Hardware changes on ADC and DAC for JESD204B Tx and RX Porting on Elitestek FPGA

Date: 25th February 2025

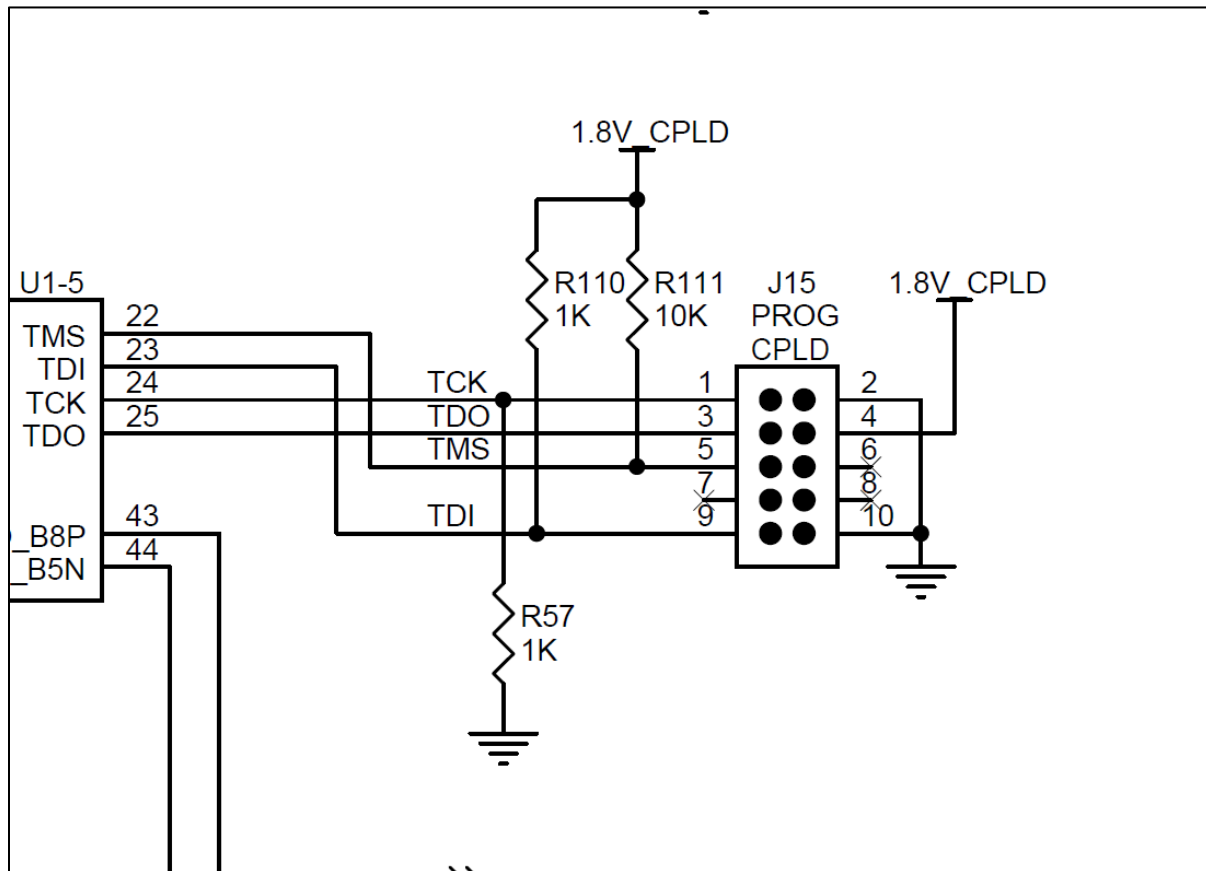
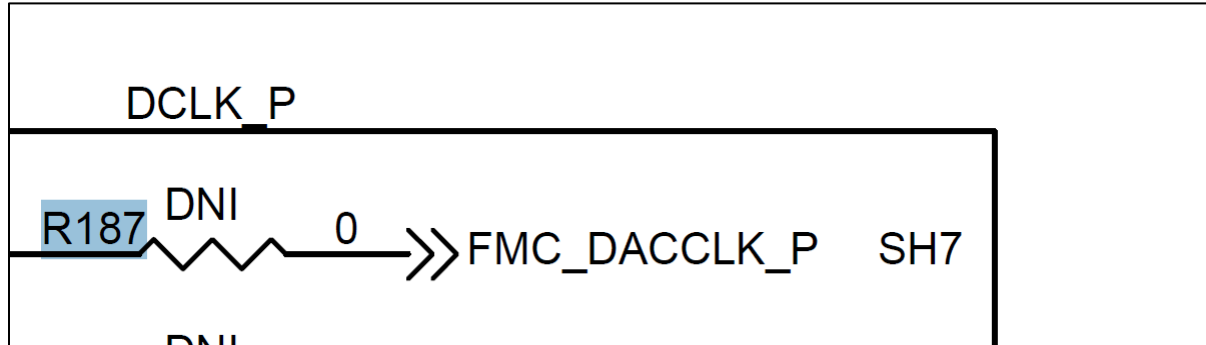
To prove the deterministic latency, the sample trigger needs to be mapped to the GPIO header, but the Elitestek Evaluation board doesn't have any GPIO's, also the DAC card doesn't have any GPIO's mapped to any of the header. So, the following changes are made to map the trigger signal:

- The FMC_DACCLK_P signal from the FPGA is not used in the current design.
- The signal R187 on the DAC EVM has a DNP resistor. Connect a wire from one pad of the resistor on the FMC side to the J15 header PIN 7.

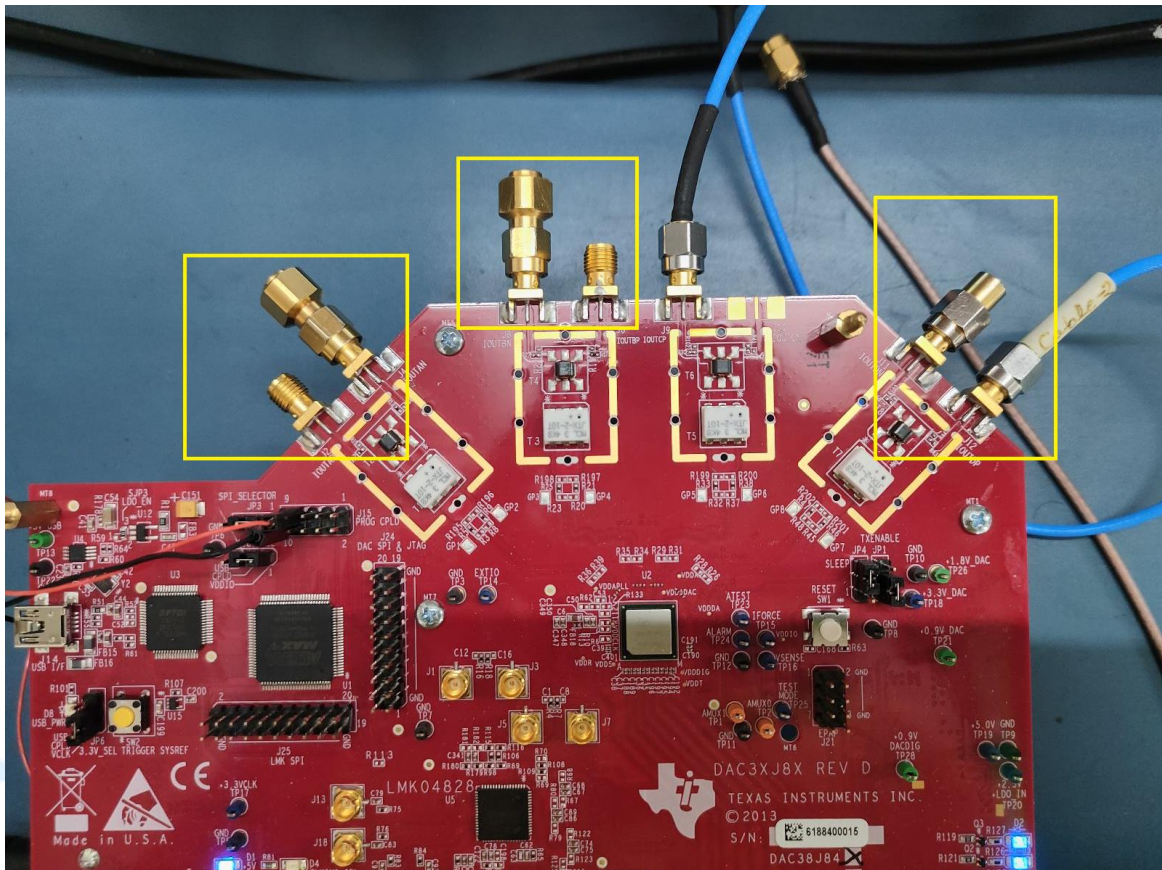
There were SMA connectors mapped on alternate polarities on channel AB and CD. To get same output on all the channels **add the SMA female connectors on other polarities wherever they are not present.**

5. External VCXO input :

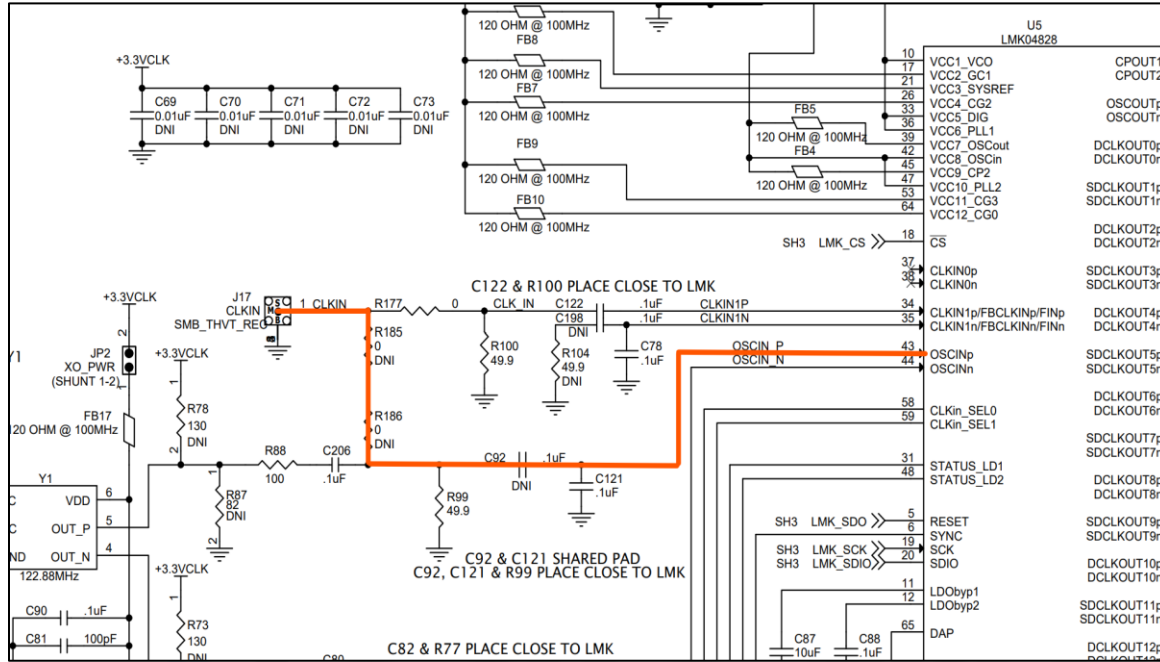
- Due to the less PDF2 value for PLL2, there was jitter on output clock which is the cause of 1.6ns variation in the output.
- So to reduce this jitter on the output clock we need to change the VCXO clock input to the LMK chip, since there is only 122.88 MHz VCXO on board, we cannot change that.
- Hence, we need to give a clock directly from some external source.
- On board there is no SMA on the OSCIN pin on LMK, so we will be using CLKIN1 SMA for this external input and through some register changes we will enable the path from CLKIN1 to OSCIN input of LMK.

To enable the highlighted path, we need to do following modifications

Reference	current state	Requirement	Remarks
R177	0 ohm	DNP	Required
R185	DNP	0 ohm	Required
R186	DNP	0 ohm	Required
C92	DNP	0.1uF	Required
C121	0.1uF	DNP	Required
R77	49.9 ohm	0 ohm	Not Required
C80	0.1uF	DNP	Required
C206	0.1uF	DNP	Required

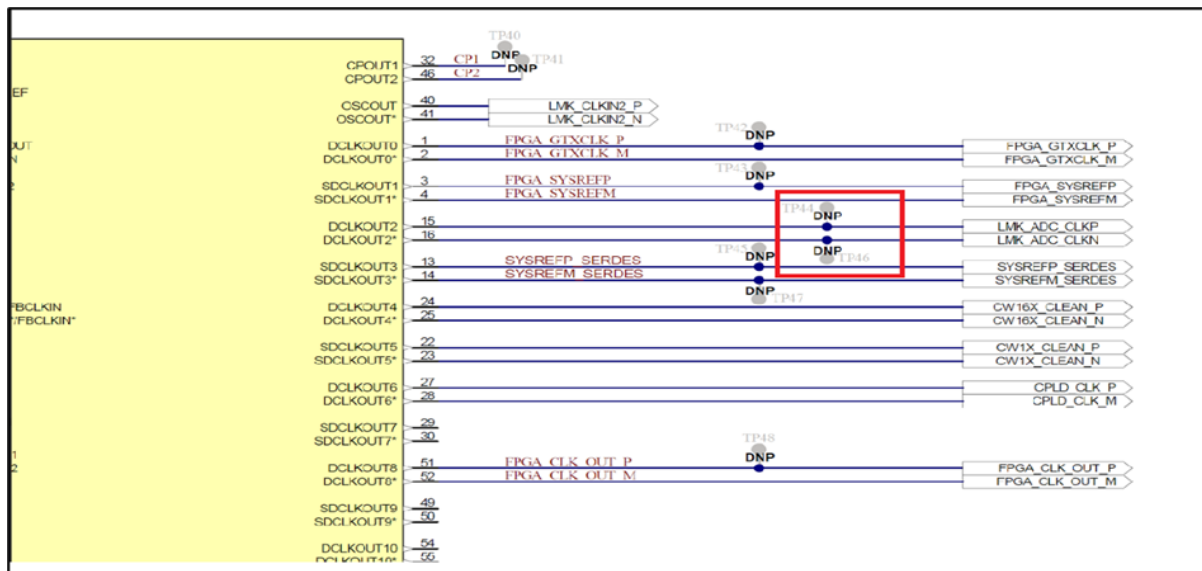
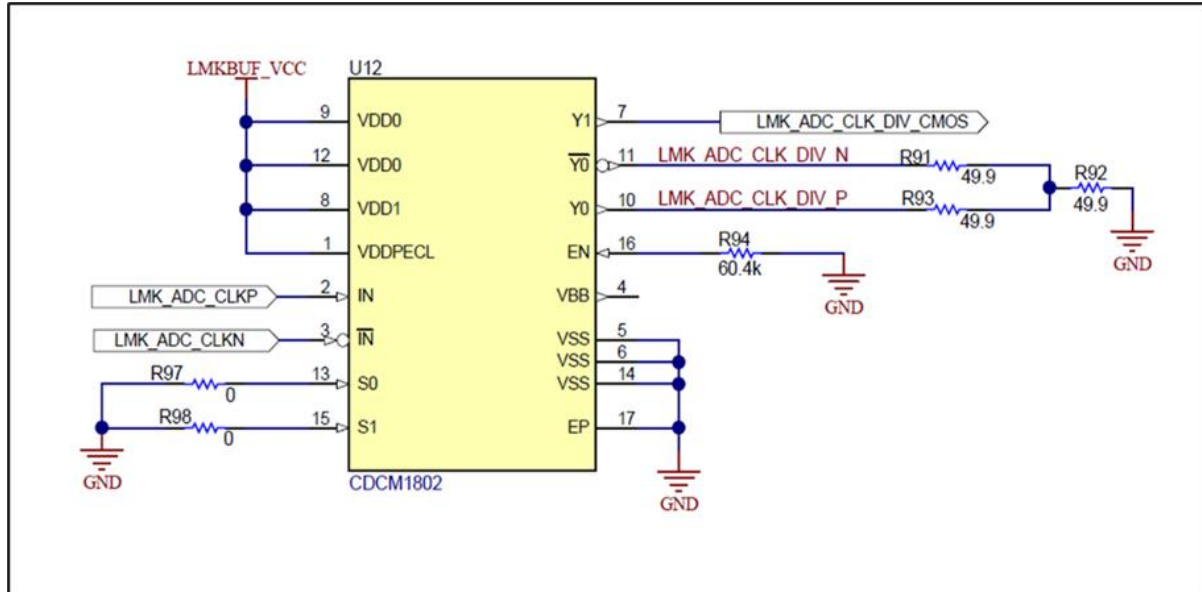
1. While testing the 40X PLL mode, the PLL was locked, but the output of the clock buffer used on the LMK to ADC path was noisy and the clock frequency was unexpected (some randomly changing frequency was observed on the scope).
2. The clock buffer datasheet recommends adding a 100ohm termination at the input for LVDS clock input because the clock buffer input is high impedance. But on the eval board there was no termination on the input.
3. To overcome this issue, we added a 100ohm termination between the test points (TP44 and TP46) provided on board on the differential clock output

- Changed the divider value of buffer in the path of LMK to ADC sampling clock

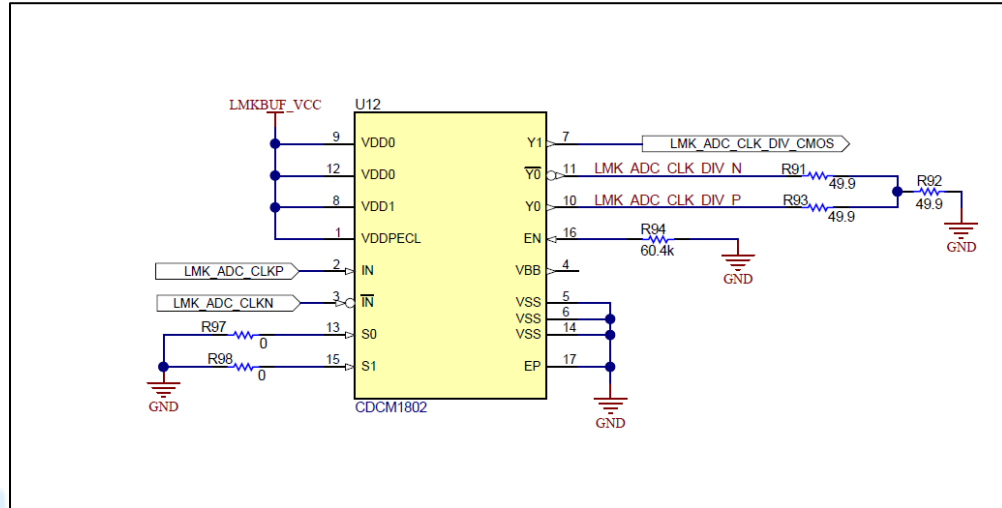
- Another GPIO is needed to prove deterministic latency, here an ADC_MSB signal from FPGA must be checked in the scope. For this purpose, one test point or header is required
- Connect the **TSW_GPIO_3** for this purpose, but there is one DNP resistor in between the path, which needs to be mounted. The resistor references are R140, so mount zero-ohm resistors on this.

- S0 and S1 pins on CDCM1802 are for divider value setting for the device, currently it is set on four that means the buffer will generate a output clock which is /4 of the input clock.
- **We need to change this divider to one.**
- As per TI this divider in the path can lead to length mismatching and since there is a factor of four between input and output so this can lead to phase variation between SYSREF and Device clock output from this divider. So, it's better to keep this divider to one to remove this ambiguity.
- As per the datasheet to make this divider one we need to change the R97 resistor value from 0ohm to 60k ohm.

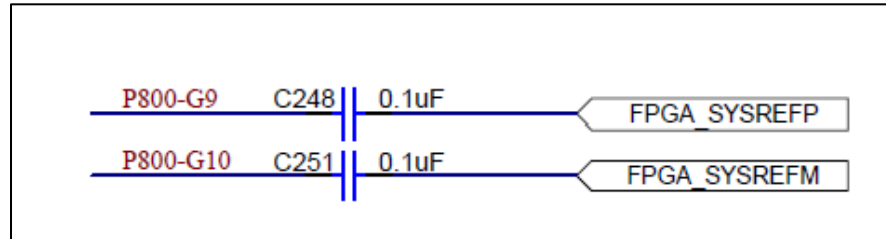
- Removal of AC caps on the sysref path to FPGA.
 - Remove the 0.1uF capacitor on the path and replace it with 0 ohm resistor to improve the slew rate on the sysref path.
 - Change C248 and C251 on the path to 0ohm resistor.
